THE BABCOCK & WILCOX COMPANY
POWER GENERATION GROUP

Cust. Florida Power Corp.

Subj. CR-3, Cycle 3 Reload Report Amendment

Date
May 30, 1980

Figure 3-3. Control Rod Locations

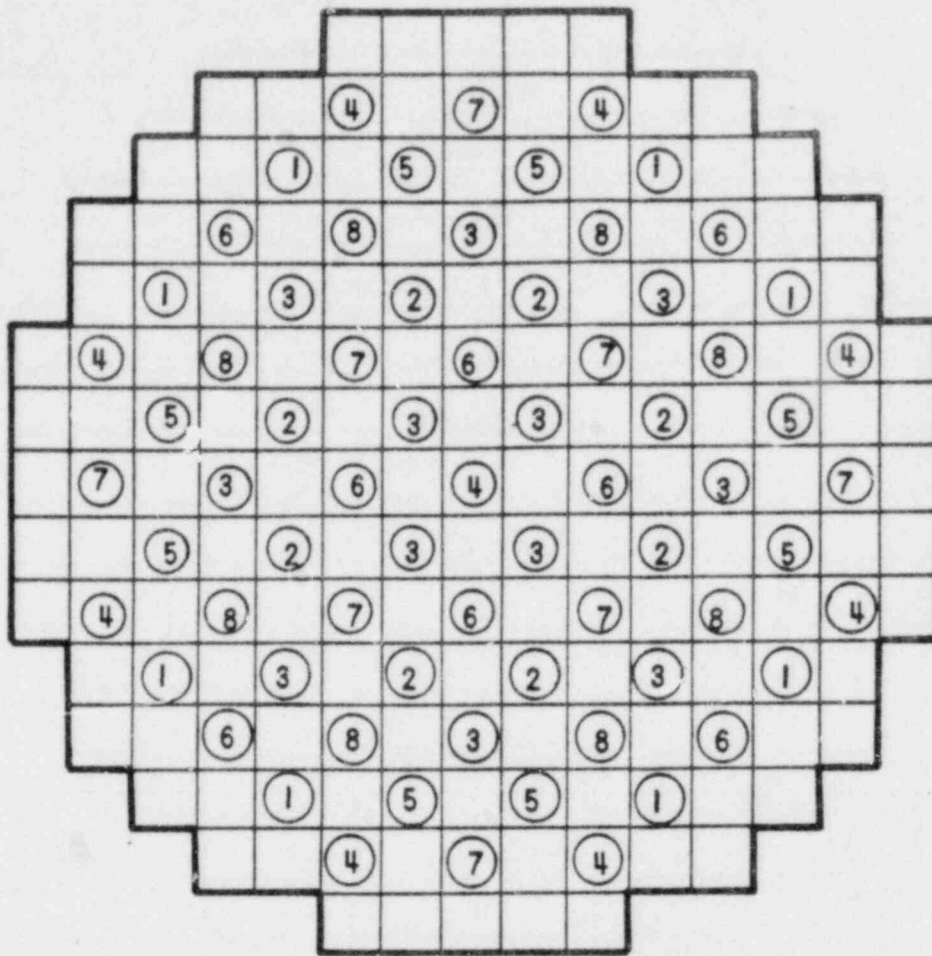
Core reactivity will be controlled by 61 full-length Ag-In-Cd control rod assemblies (CRAs) and soluble boron shim. In addition to the full-length CRAs, eight axial power shaping rods (APSRs) are provided for additional control of the axial power distribution. The cycle 3 locations of the 69 control rods and the group designations are unchanged from cycle 2 and are shown in Figure 3-3. Control rod group 7 will be withdrawn at 250 ± 10 EFPD of operation.
